Appl. No. 10/502,184
Amdt. dated Apr. 4, 2006
Reply to Office Action Mailed Jan. 11, 2006

Amendments to the Drawings:

REMARKS/ARGUMENTS

2/2 3/3

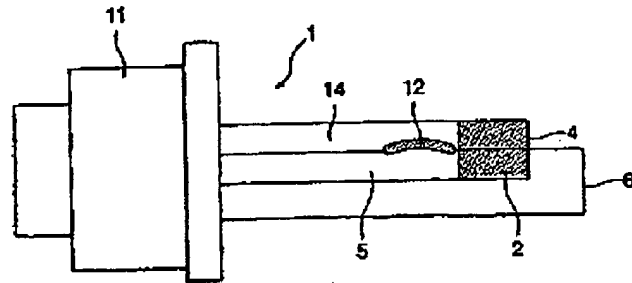
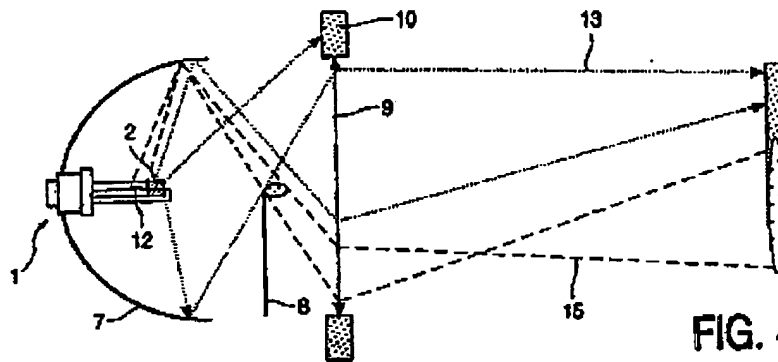
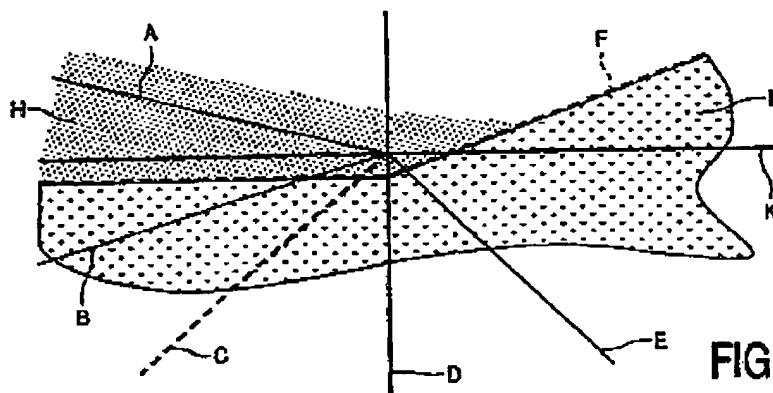
The third attached sheet of drawings changes the sheet containing Fig.'s 3-5, formerly sheet 2 of 2, to sheet 3 of 3.
